FIELD SAFETY NOTICE

Date: 2010-02-02
Author: Trina Turcotte, tturcotte@bhm-medical.com
Subject: FSN01/2010/ca.EN
Product group: Floor Lifts
Document number: FSN01/2010/ca.EN
Issue: 1
Case No: NA

SINGLE INSULATION POWER CABLE

Fig 1: Power cable location

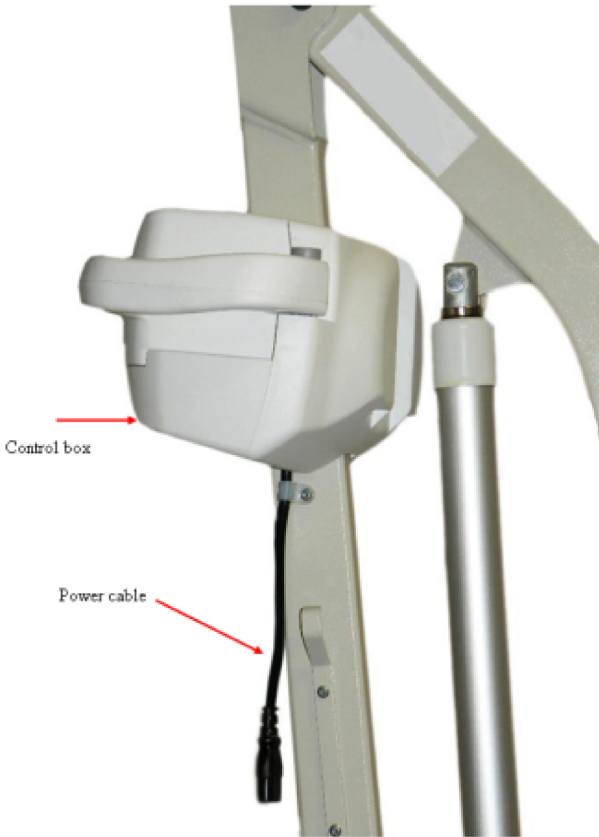
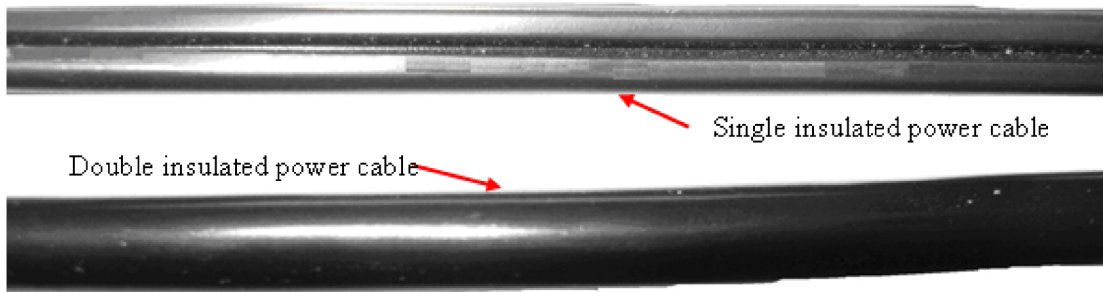
During the assembly of some of the above mentioned products, an improper power cable was installed on the control box. This power cable is single insulated, which increases the risk of premature failure.

A power cable failure could result in a connection between the metal structure of the hoist and the main power. Therefore, there is a risk of electrical shock for the user while the hoist is plugged to an electrical outlet.

The single insulated power cable will be replaced, free of charge, by our dealers/distributors.
